RECALL BULLETIN:
10625FRV

PRODUCT(S) AFFECTED:
Encounter,
Storm

SUBJECT:
Providing
Egress for
Driver's Side
Bedroom
Window

ISSUE DATE:
July 2010

Figure 1

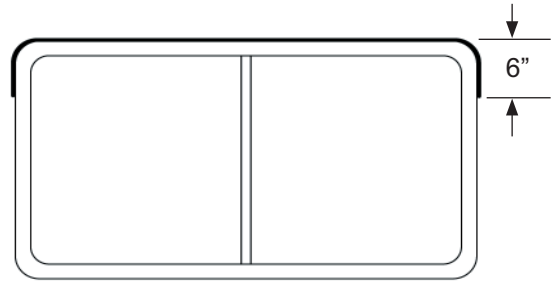
5. Install the new emergency egress window using the compression seal and screws supplied in the Recall kit. Apply a 1/8" bead of clear silicone sealant to the exterior upper six inches of the new window frame after installation. See Figure 1.
